Subject: Project name ADDITION - DORSEY RESIDENCE
Project site address 14700 CARRIAGE MILL RD
Permit # 13 2200274 SDP # _____
Other information pertinent to this project _____

Revision #2

From: Oswald, Hank
Sent: Monday, July 25, 2022 11:21 AM
To: C.E.DORSEY@VERIZON.NET
Cc: ASHRAF.SHAKER@ASHTREE-ARCH.COM
Subject: B22002743_14700 Carriage Mill Road_Living Space Addition/Inlaw Suite
Attachments: A43364_04-358260_14700_CARRIAGE_MILL_DRIVE.pdf; Percolation & Plan Requirements For Developed Lots.pdf; Building Permit Application Process.pdf; Well and Septic Setback Distances.pdf; ENGINEERS_2.4.2020.pdf

PROJECT:
**DORSEY RESIDENCE
HOME ADDITION**

EX. BASEMENT
FLOOR
PLAN

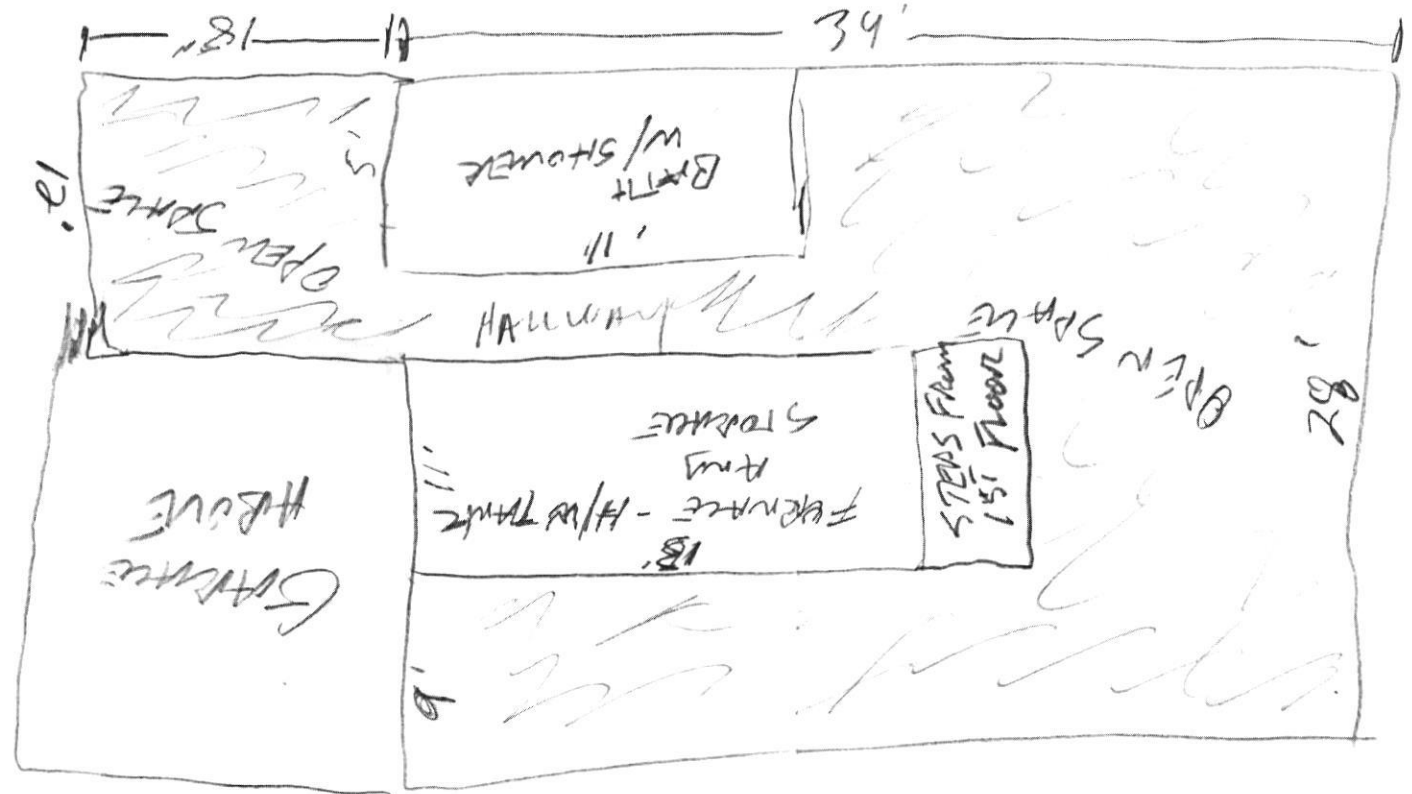
- Provide simplified floor plans of the existing house to get a total bedroom count. While the proposed addition shows to 2 labeled bedrooms, the "office" is also considered a bedroom unless the opening into the room is widened to 4 feet and cased without a door. There are other ways to make the office a non-bedroom. This is just one of them.

- ☐ Letter of response to address plan review comment letter
- ☒ Revised plans and/or revised details: When submitting for a complete re-review, **duplicate sets shall be submitted.**
- ☐ Letter Summarizing Changes
- ☐ Energy conservation calculations
- ☒ 3 Copies of 2nd FLOOR PLAN (be specific).
BASEMENT FLOOR PLAN
- ☐ Health Department Request ☐ DPZ/ DED Request ☐ Applicant's Request
- ☐ Two sets of single family dwelling model plans to be placed on permanent file: Model name and/or # _____
- ☒ Other DELETE DOOR @ OFFICE AREA - BASEMENT FLOOR PLAN
DETAILS AREA
